**Proposed High Wycombe South (Forrestfield North) Residential Precinct Local Structure Plan Amendment**

**Schedule of Submissions**

11. The modifications proposed by this Submission are reflected in Figure 3 – Proposed Structure Plan Modification.

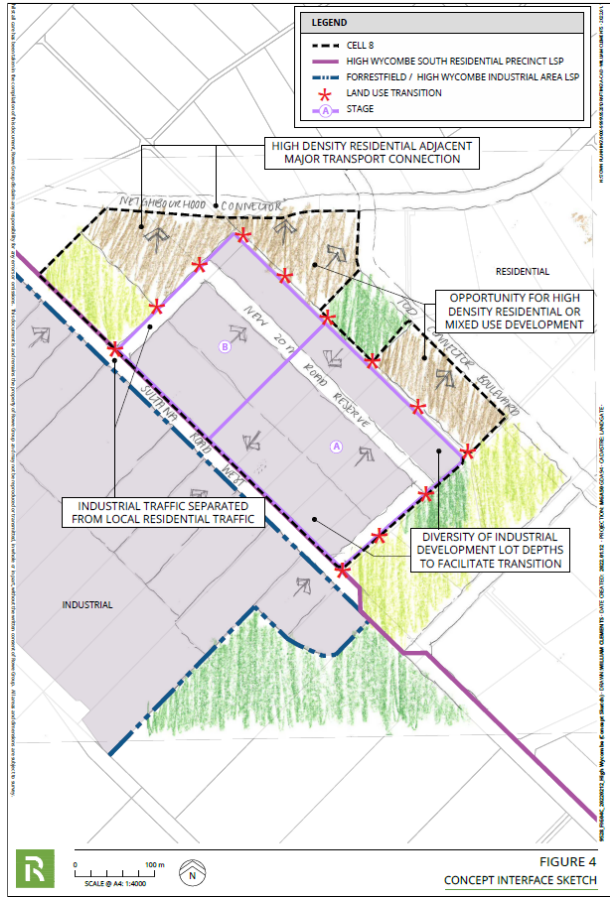
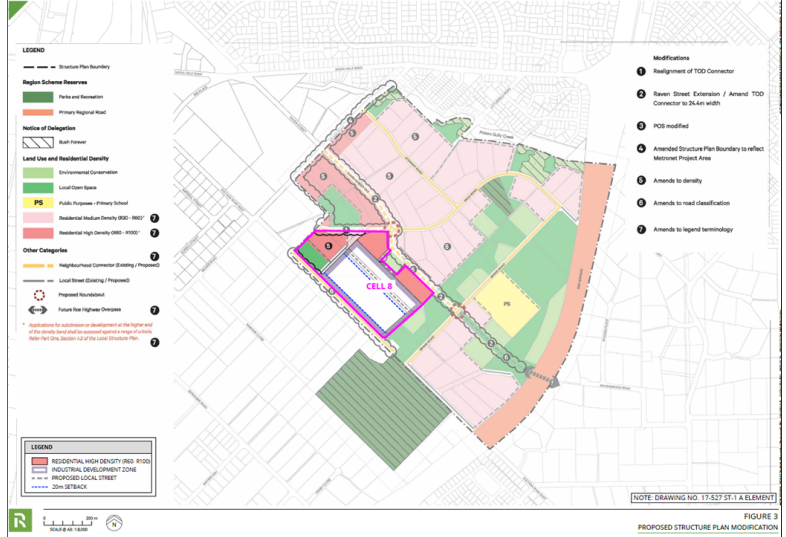
12. Further to this, it is requested that the following provisions are included within Part 1 of the Structure Plan:  
**4.2: Industrial Development Zone**

<p><i>a) Industrial subdivision is to meet the requirements of the Scheme and WAPC Development Control Policy 4.1 – Industrial Subdivision, unless otherwise specified.</i></p> <p><i>b) A minimum lot size of 1,000m<sup>2</sup> applies to any subdivision of land identified as Industrial Development zone.</i></p> <p><i>c) Buildings shall be setback a minimum of 10-metres from the street, unless otherwise identified on the Structure Plan.</i></p> <p>The above provisions are consistent with the requirements for the Industrial Development Zone set out in the Forrestfield/ High Wycombe Industrial Area Stage 1 Local Structure Plan.</p>	<p>It is noted the Forrestfield/High Wycombe Industrial Area – Stage 1 LSP requires approximately one (1) hectare lot size (i.e. 10,000m<sup>2</sup>), except for Lot 50 Sultana Road West allowing for 3,000m<sup>2</sup> lot size subject to criteria.</p>
	<p>13. Summary - We confirm that our Client is generally supportive of the layout and land uses contemplated by the proposed Amendment to the Forrestfield North Residential Precinct Local Structure Plan, subject to the inclusion of a “transition zone” within the Cell 8 precinct. We reiterate our concerns that the existing, operating land uses south of Sultana Road West, and their associated adverse impacts (in particular, heavy traffic movements and noise) are not considered or addressed by the proposed Amendment to the Structure Plan. If landowners were to progress a residential outcome over the site, as contemplated, undesirable built form measures (i.e. acoustic barriers, slip roads, and/or additional open space) would be required to be provided to protect the amenity of adjacent residential development. We are of the view that a considered approach to land use zoning (such as the extension of the ‘Industrial Development’ zoning and considered movement network) represents a better built form and amenity outcome for the overall locality.</p> <p>On this basis, we request that the proposed Amendment to the Forrestfield North Residential Precinct Local Structure Plan be modified to include an appropriate transition treatment as depicted by Figure 3. Given the extent of our Client’s concerns, we would appreciate the opportunity to meet and discuss the proposed Amendment with the City’s Planning Department. In this regard, could you please contact the undersigned on XXX XXXX to organise a convenient date and time. We trust the information contained within this submission assists your deliberations of the proposed Amendment to the Structure Plan and look forward to hearing from you shortly.</p>	<p>13. Noted. City staff have met with the submitter as request regarding this matter. See Submitter 8, Comments 4 to 7 and 12 above.</p>

*The indicative staging is shown diagrammatically in Figure 44, with a further explanation provided below:*

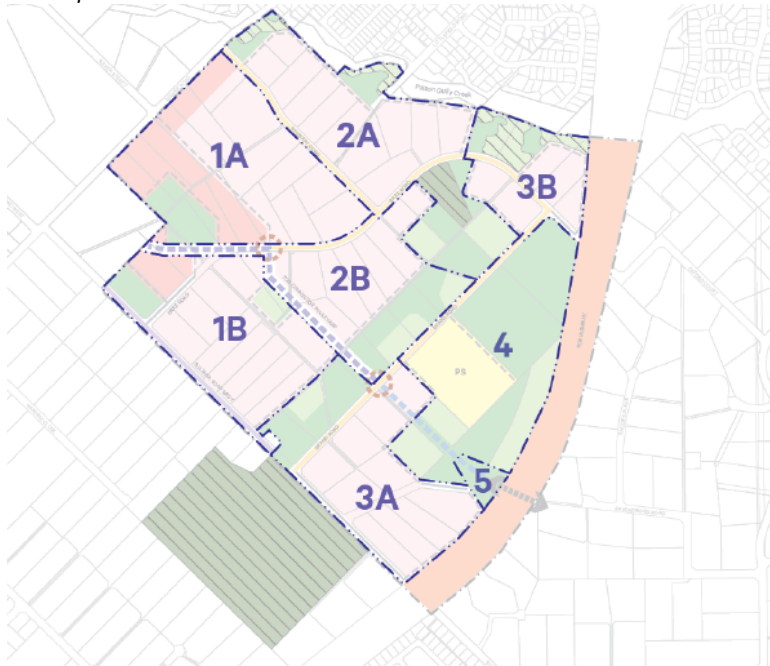
6. CLAIMS BY THE CITY ABOUT SELLING SEQUENCE NEED TO BE SUBSTANTIATED - The City of Kalamunda forecasts that Cell 8 will be the second phase to sell in this precinct. Refer page 2040. I ask the City to provide the reasons for making this claim, or else change the ranking in Amended LSP and the map shown below.

5. Noted. See responses to Submitter 8, Comments 4 to 7 and 12, and Submitter 9, Comment 2 above.

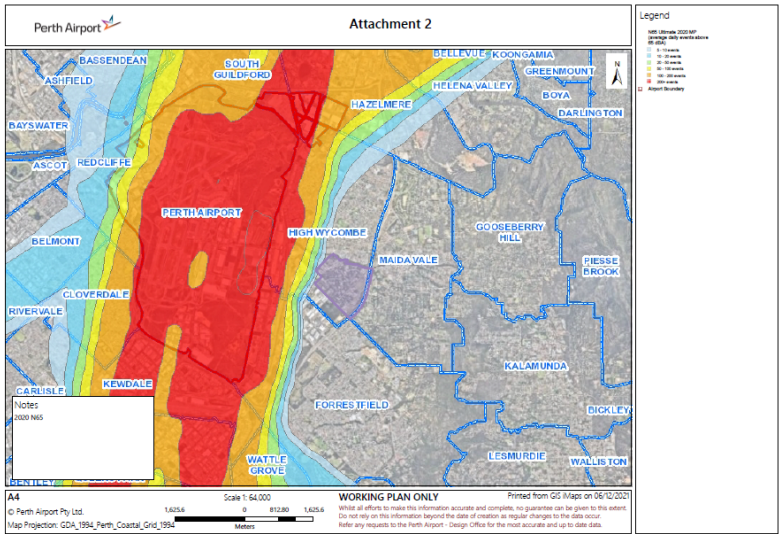
6. Using the NASF recognised N65 contour, the western portion of the subject site will experience up to 10 aircraft noise events above 65 decibels across an average day. Noise at this level is disruptive to a normal conversation even inside a dwelling and will be unacceptable to most people. It is worth noting that the area will receive a significant number of additional aircraft noise events at a level less than 65 decibels, and these noise events may also cause annoyance to some people. The N65 overlaid with the subject area is included in Attachment 2.

6. Noted. Assessment of transport noise will be assessed on a case-by-case basis at the time of future development, including assessment of aircraft noise pursuant to State Planning Policy 5.1 Land Use Planning in the Vicinity of Perth Airport, and potential attenuation measures.

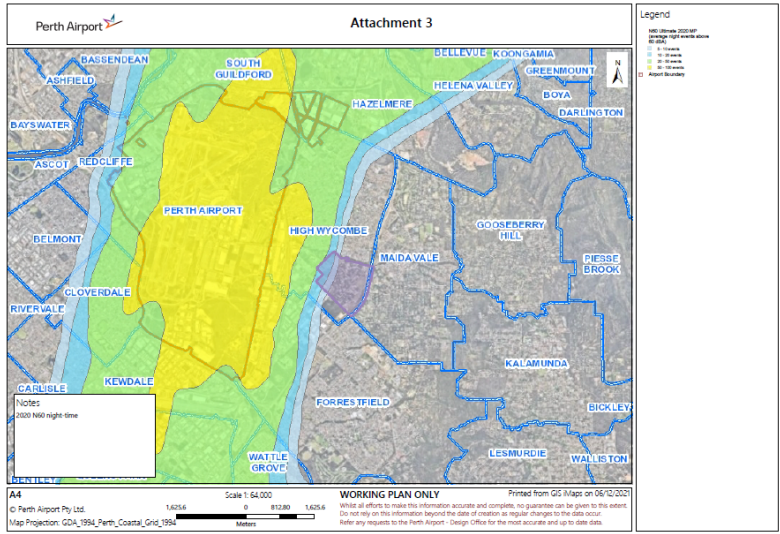
7. An additional NASF recognised noise metric is the N60, which shows the number of events in excess of 60 decibels that can be expected over an average night (11pm-6am). The lower threshold was chosen to reflect people's increased sensitivity to noise in this period. The subject site will experience up to 20 aircraft noise events above 60 decibels across an average night. The N60 overlaid with the subject area is included in Attachment 3.
